From your friends at New York Bus Sales

Product Effected – Blue Bird Type C&D

Complaint - The unit appears to have a fuel leak at the tank -

Figure #1

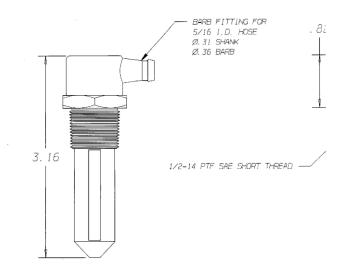
There was a new style vent that was used in production which is pictured in Figure #1, this vent contacts fuel at a lower level than the first production vent which is shown in Figure #2. If you look at the design of the tank, especially those "midmounted" in the frame even if the "first-click" method is used in fueling the tank it will allow the tank to take on more fuel as there is a 2-1/2" fuel fill line from the tank to the fuel fill which needs to be filled with fuel before it will "clock off".

This higher level also causes the tank to allow fuel to be released from the vent line which would appear as a fuel leak.

Once you are sure this is the location of the leak you should pull the vent and inspect. The "new" style vent should be replaced with the "old" style vent. In changing the vents you are raising the fuel contact point of the vent which if the

Just to avoid any issues it might be recommended that these vents be removed and replaced with the new #10013053!
